Re: Indian Point Unit No. 2
Docket No. 50-247
NL-06-020

Subject: Application for a Technical Specification Change to Add Spent Fuel Cask Loading Requirements

**ANALYSIS OF PROPOSED TECHNICAL SPECIFICATION
CHANGES REGARDING THE ADDITION OF SPENT FUEL
CASK LOADING REQUIREMENTS**

**MARKED-UP TECHNICAL SPECIFICATION AND CORRESPONDING
BASES PAGES REGARDING THE ADDITION OF SPENT FUEL CASK
LOADING REQUIREMENTS**

Figure 3.7.16-1
Fuel Assembly Burnup Limit Requirements for Cask Storage

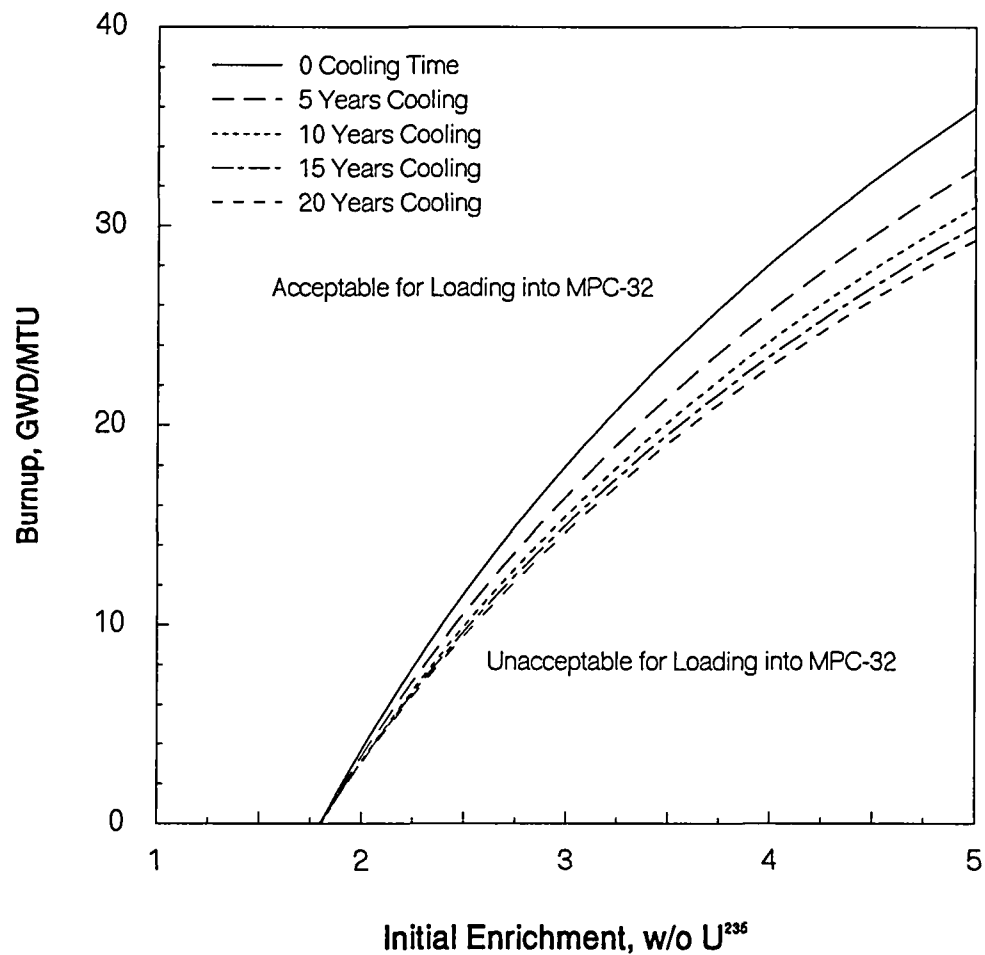
3. A new TS Limiting Condition for Operation will be added, LCO 3.7.16, to identify that there are fuel assembly initial enrichment and burnup loading restrictions for the MPC-32 storage cask included in TS Figure 3.7.16-1. Associated with this LCO is a new proposed Bases B 3.7.16.

4. A new Surveillance Requirement, SR 3.7.16.1, will be added to verify that the fuel assemblies are placed in a MPC-32 storage cask within the limits of Figure 3.7.16-1.

5. A new TS Figure, Figure 3.7.16-1 will be added that specifies acceptable combinations of fuel assembly initial enrichment, burnup and cooling times for MPC-32 cask loading operations.

LCO 3.7.16 The combination of initial enrichment and burnup of each spent fuel assembly stored in the cask storage area shall be within the acceptable burnup domain of Figure 3.7.16-1.

- 4.3.1.3 The spent fuel casks are designed and shall be maintained with:
- a. Fuel assemblies having a maximum U-235 enrichment of 5.0 weight percent;
 - b. $k_{\text{eff}} < 1.0$ if fully flooded with unborated water;
 - c. $k_{\text{eff}} \leq 0.95$ if fully flooded with water borated to 250 ppm;
 - d. A nominal 9.218 inch center to center distance between fuel assemblies placed in the spent fuel cask; and
 - e. Spent fuel assemblies with a combination of discharge burnup and initial enrichment in the acceptable burnup domain of Figure 3.7.16-1.
